We would like to register our concerns about the proposed development at "Tamarind" Old Church Lane, Fylingthorpe.

10 June 2010
My Ref: MJM/ABB/1
Your Ref: NYM/2010/0386/FL

**OBJECTION in respect of Planning Application Ref: NYM/2010/0386/FL
Erection of Extension, Tamarind, Church Lane, Fylingthorpe, YO22 4PN**

Appendix 1: Photographic evidence of flooding

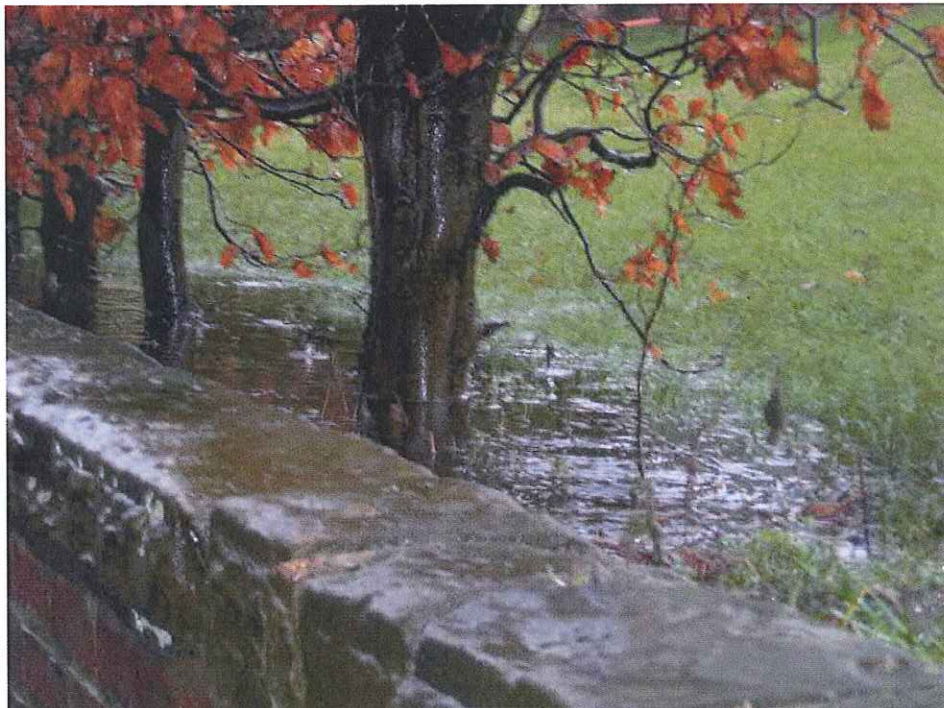
The proposed development site is higher than the row of properties to the south-east known as Inglenook Cottage, Melrose Villas and Melrose House and slopes down towards them. Mr and Mrs Abbott and their neighbours Mr Pell and Mrs Philips have confirmed that during periods of intense rainfall their properties are affected by substantial surface water run-off from the proposed development site.

Photographic evidence of such flooding is provided at Appendix 1. During intense periods of rainfall, water flows through and over the small wall at the bottom of Tamarind's garden, which forms the boundary with Inglenook Cottage, Melrose Villas and Melrose House. During these events, the neighbours have to use sandbags in order to prevent inundation of their homes by water. Mr and Mrs Abbott are particularly affected as the water flows along the passage way behind the wall and into their garden/yard area.

All three neighbours are concerned that the proposed development may exacerbate the existing problem that they experience. For example, a substantial area of new roofing will be provided in the proposed development that will yield extra surface water run-off.

**Appendix 2: Photographs of the Proposed Site and its relationship to
Inglenook Cottage**

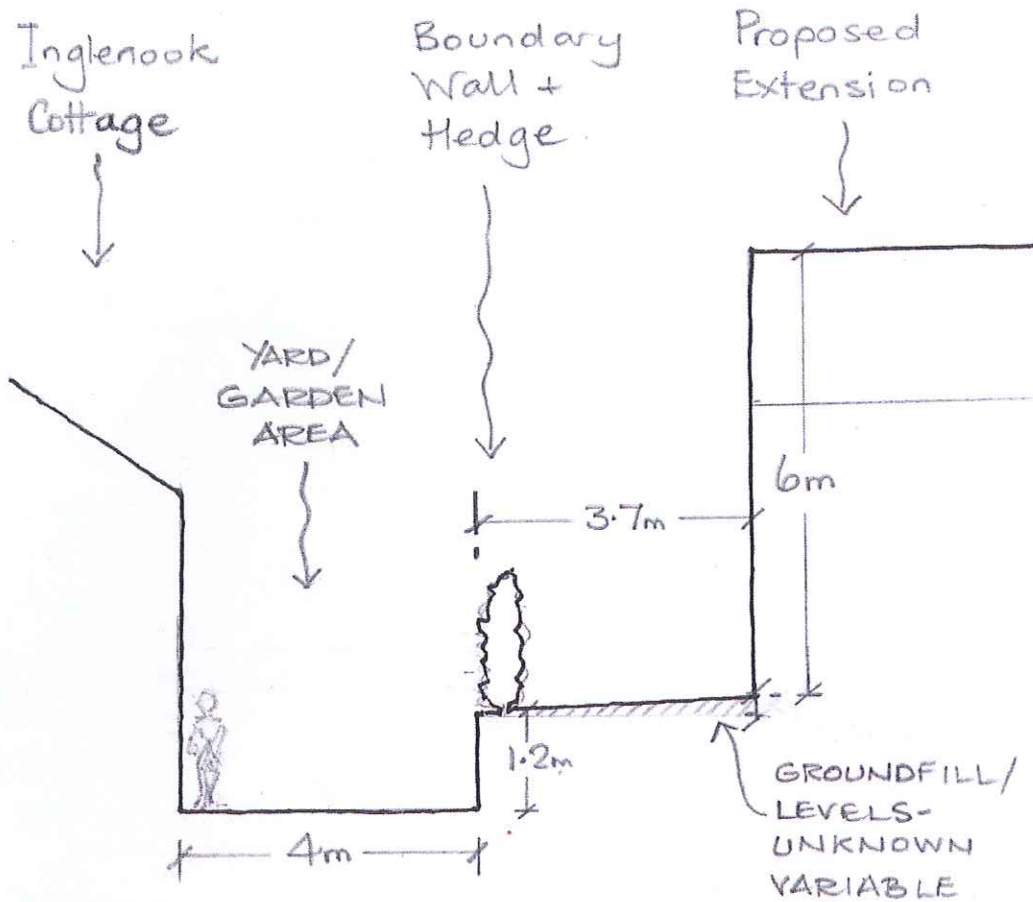
These features and their relationship to existing development are shown on Photograph 1 at Appendix 2.

Photograph 2 at Appendix 2 shows that there is a gap in the beech hedge along part of Inglenook's rear boundary with the proposed site and that Tamarind is clearly visible. This existing situation is just about tolerable in terms of residential amenity.

Whilst the hedge is attractive and provides vital screening for privacy, the adjacent passageway is extremely narrow (as evidenced by Photograph 3 at Appendix 2) and is generally in shade. Any further enclosure of this private space would be unacceptable. Hence, provision of close-boarded fencing along this boundary for example would be extremely oppressive and unacceptable in planning terms.
